Dromore West Village Enhancement Committee

Date: 25th September 2026

Re: Case Ref. 324561 (PAX21.324561) – Crumhach Wind Farm, Co. Sligo. Application by SSE Renewables (Ireland) Ltd. for the removal of 23 no. existing turbines, the erection of 17 no. wind turbines and associated works in the townlands of Crowagh or Dunneill Mountain, Ballyglass, Tawnadremira, Doonbeakin, Dunowla, Kingsmountain, Ballygreighan Barr, Corhawnagh, Abbeytown, Knockaculleen, Rathgoonaun, Lecarrow and Dromore, Co. Sligo

Photograph B1: The Millennium Rock on the paved corner at the junction of the N59 and the R297 (the Easkey Road), on the inside of the turn at Location 15. Source: Google Street View.

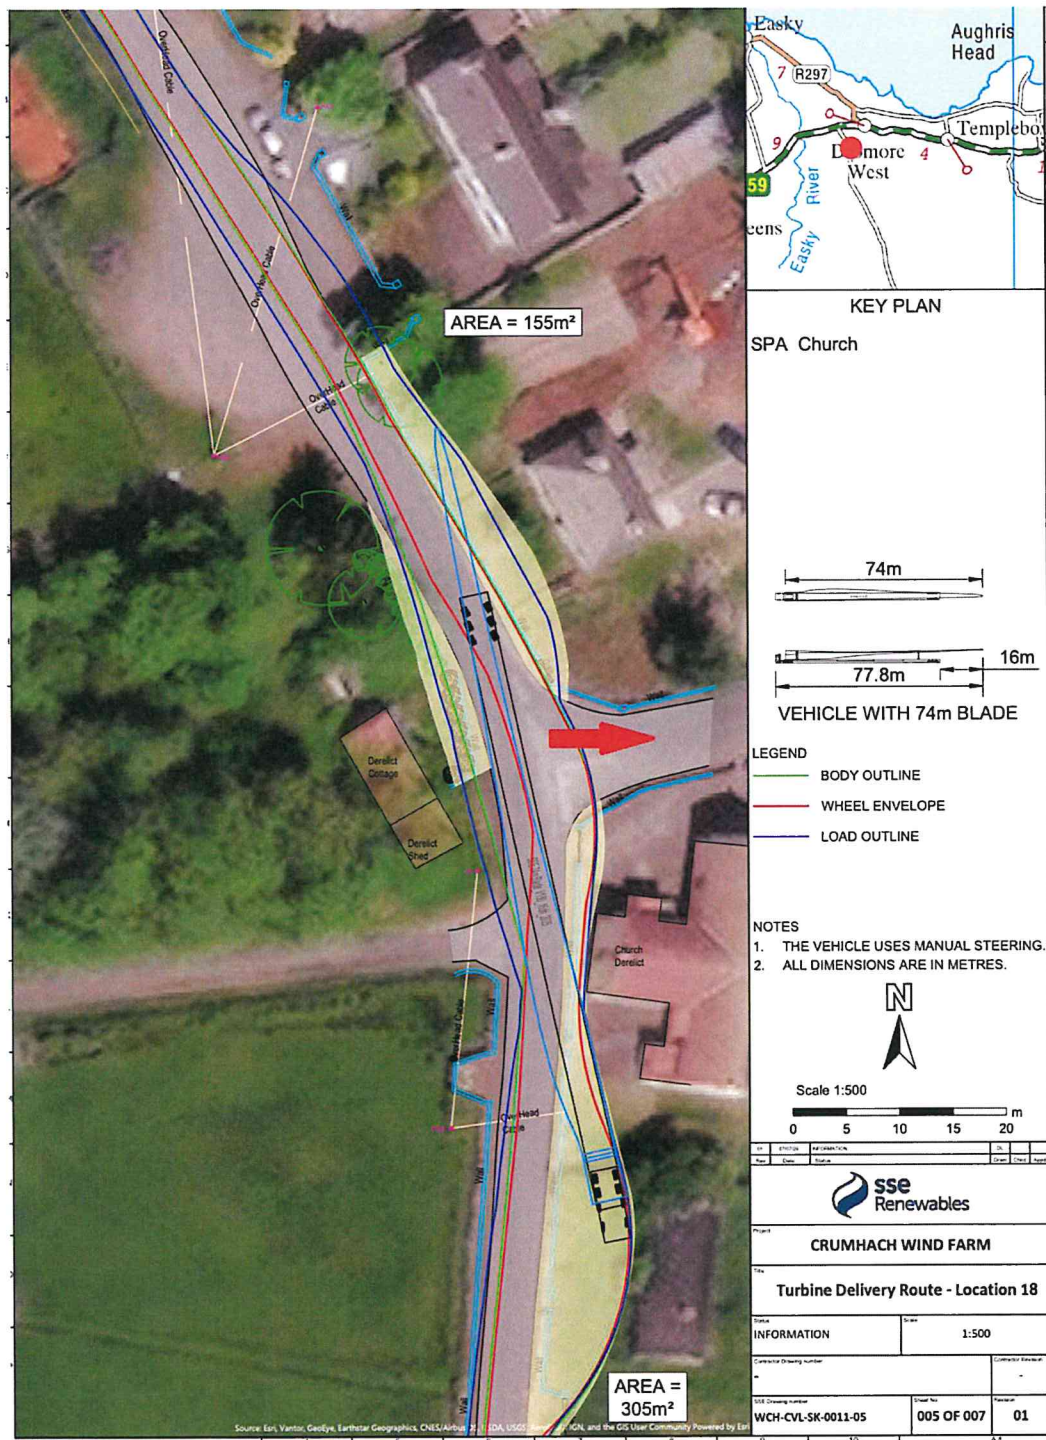
- 2.5 **The Millennium Rock.** A substantial rock, unveiled in 2000 to mark the millennium, stands on the paved corner on the inside of this turn, immediately beside the path of the transporter. It is a well-known local landmark and a symbol of community pride. The monument was commissioned and erected by the local community of Dromore West and the Kilmacshalgan parish. It serves as a permanent, physical marker of the millennium milestone for the village of Dromore West. Moving it strips away the historical context of where the community originally gathered to welcome the year 2000.

It is not shown on the swept-path drawing, and the Committee could not find it mentioned anywhere in the EIAR. The Committee asks the Commission to require the applicant to confirm the position of the Millennium Rock in relation to the swept path; to protect it in place throughout the works; and only if moving it is unavoidable, to do so with the agreement of the community, using specialist contractors, and to reinstate it at the applicant's cost at a location agreed with the Committee. Its position is marked on the drawing at Appendix A, and photographs are attached at Appendix B. A photographic record should be made before any works begin. The Committee also asks, as further information, for detailed design drawings of Location 15 showing all existing features, everything to be removed, footpath strengthening and full reinstatement, and a swept path based on the largest blade and vehicle that could be used.

- (t) Protection in place of the Millennium Rock at Location 15 throughout the works, with a pre-works photographic record; if moving it is unavoidable, relocation only with the agreement of the Committee, by specialist contractors, and reinstatement at the applicant's cost at a location agreed with the Committee.
